I-25 AND COUNTY LINE ROAD
60% SUBMITTAL
EL PASO COUNTY, COLORADO

EL PASO COUNTY TRAVEL CENTER
PREPARED FOR
BUC-EE'S, LTD.
COVER SHEET

V1_Roadway Plan Sheets.pdf Markup Summary

DESIGN DATA	COUNTY LINE RD (MINOR ARTERIAL)	BEACON LITE RD (MINOR COLLECTOR)
MINIMUM RADIUS OF CURVE*	533	533
MINIMUM GRADE	1%	1%
MAXIMUM GRADE	6%	8%
MINIMUM S.S.D. HORIZONTAL**	305 FT	305 FT
K CREST***	44	44
K SAG****	64	64
MAXIMUM DESIGN SPEED	40 MPH	40 MPH
POSTED SPEED	35 MPH	35 MPH
E MAX	4%	4%

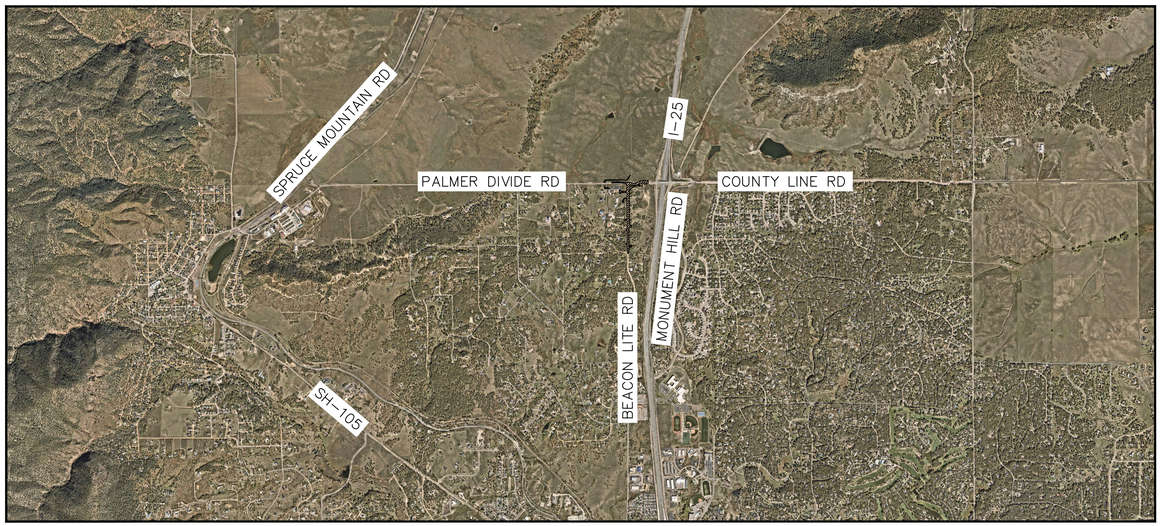
update the design data per the new roadway classifications due to the developments traffic

BEACON LITE RD
(NTS)

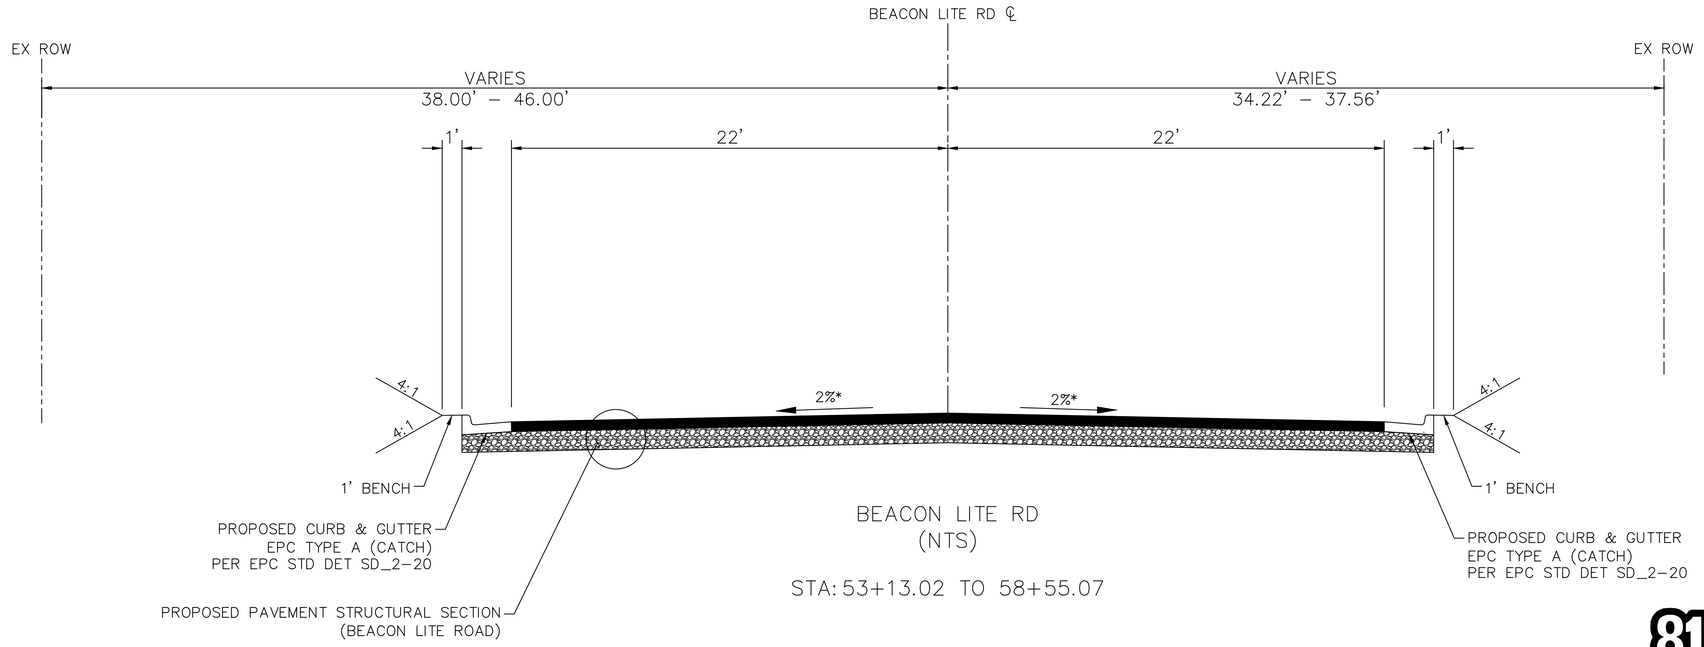
Include road classification and design/posted speeds at each section

ROUNDABOUT
(NTS)

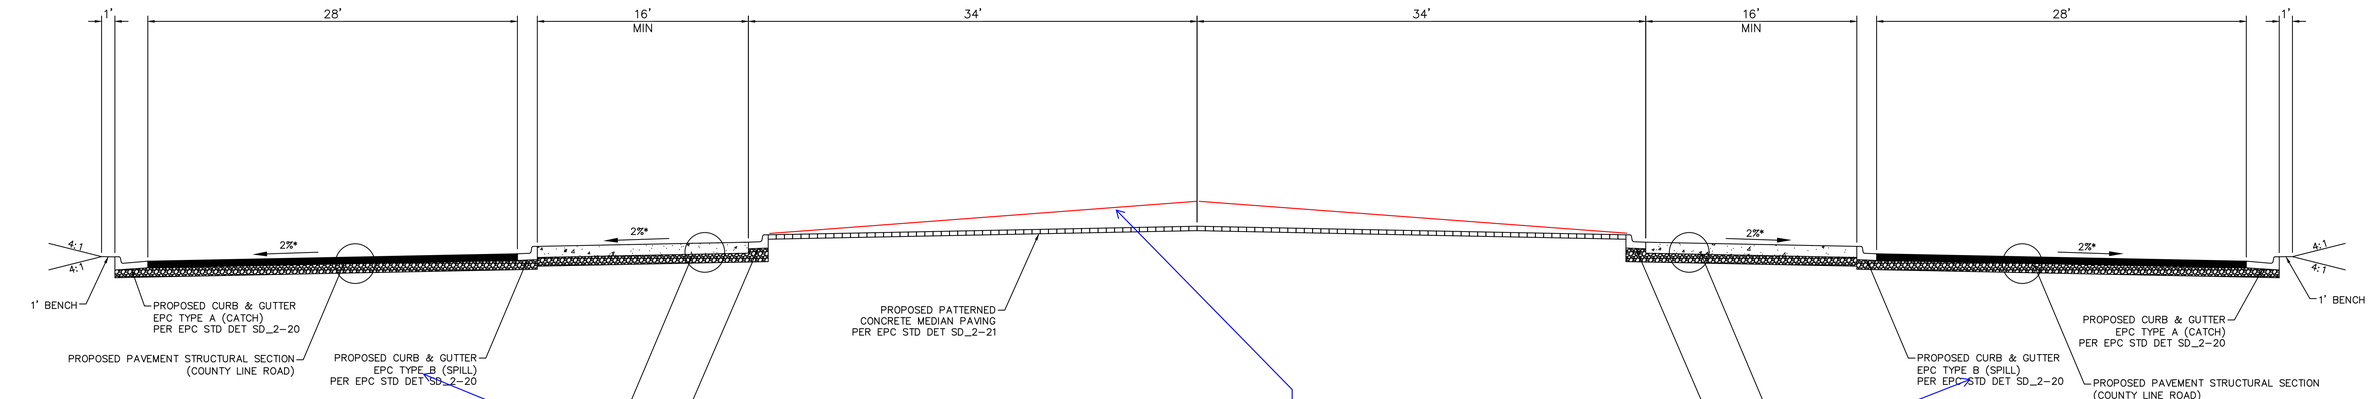
revise to ramp curb at the truck apron

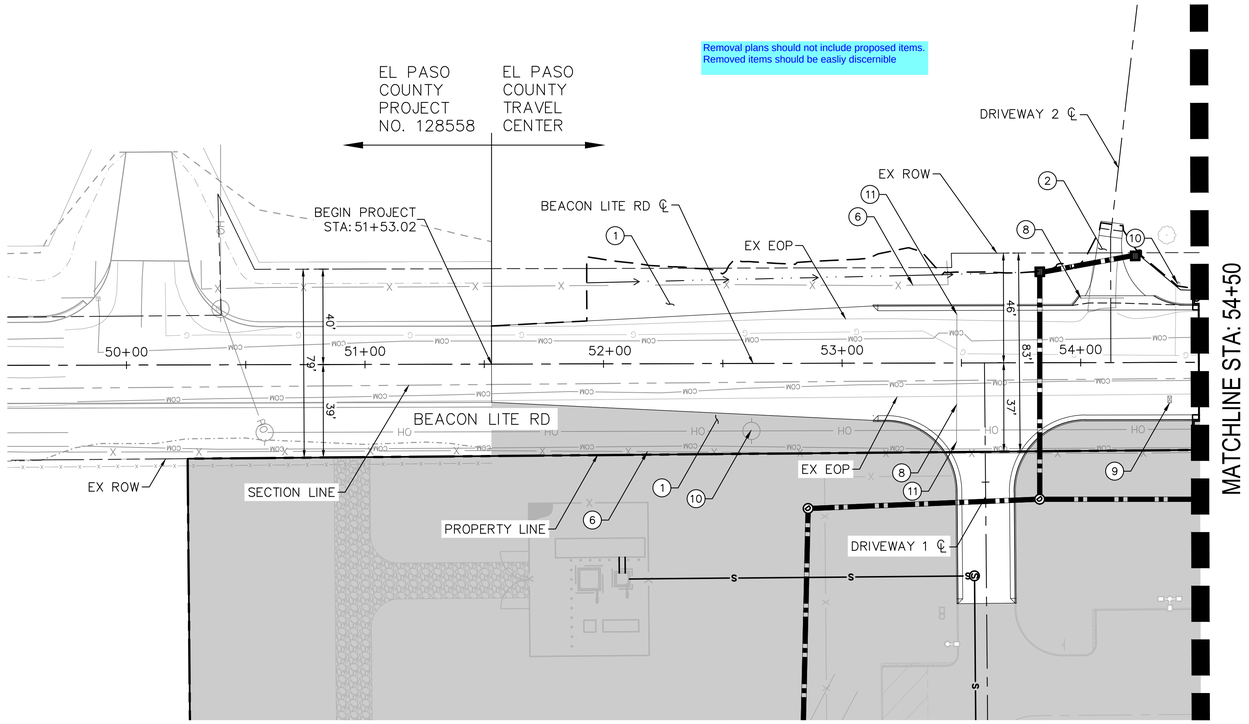
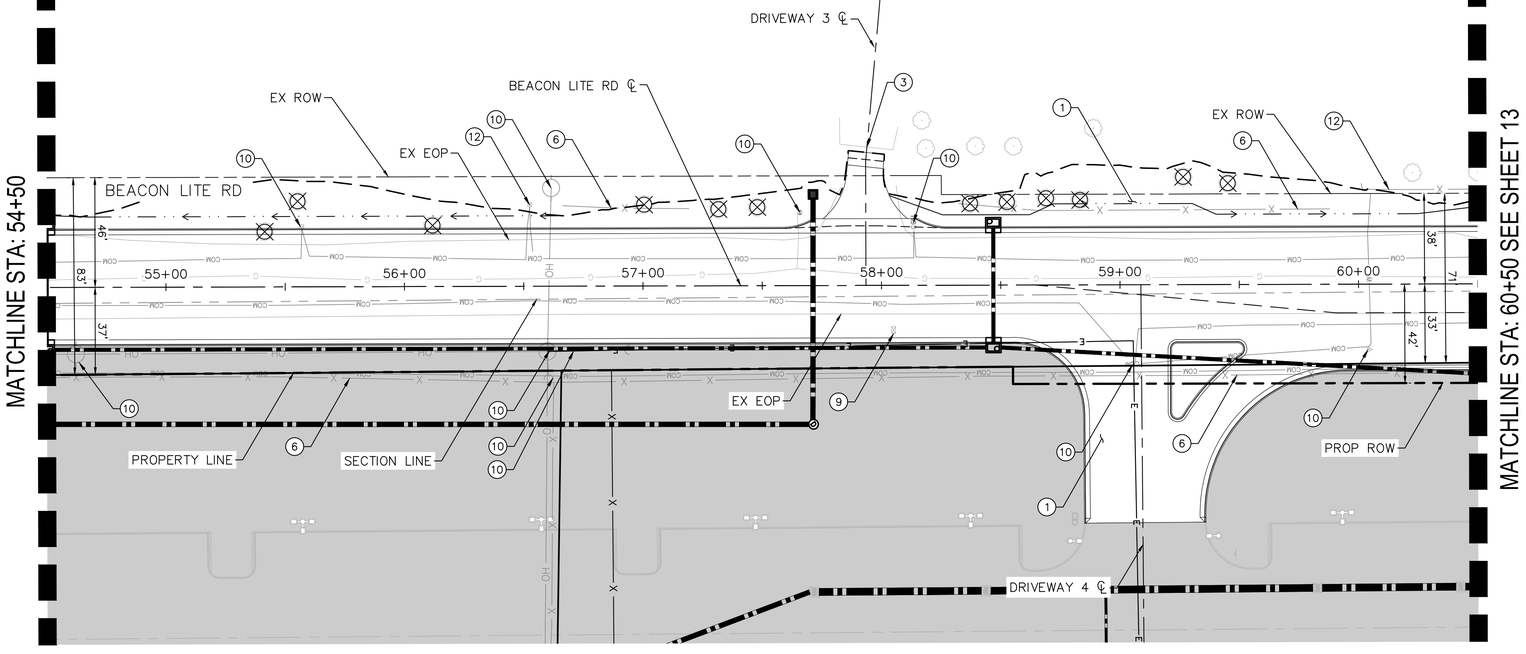
Show the Town of Monument City Limits.

Removal plans should not include proposed items.
Removed items should be easliy discernible

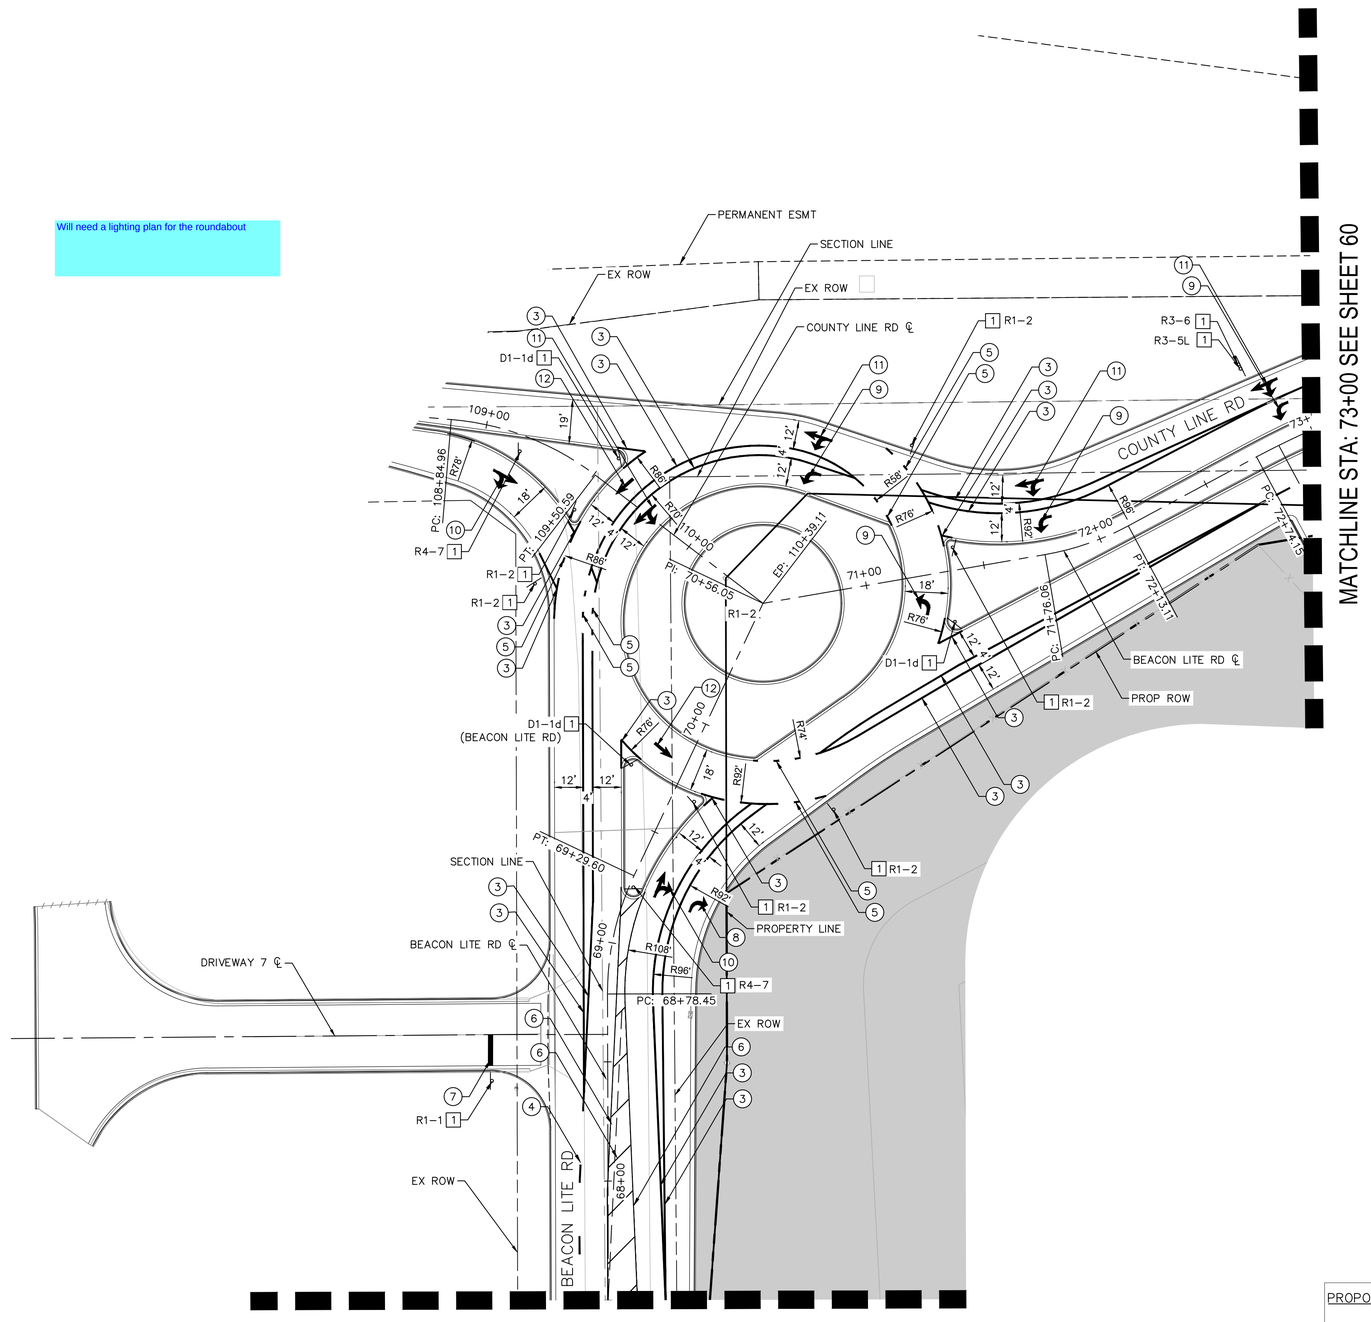
Will need a lighting plan for the roundabout
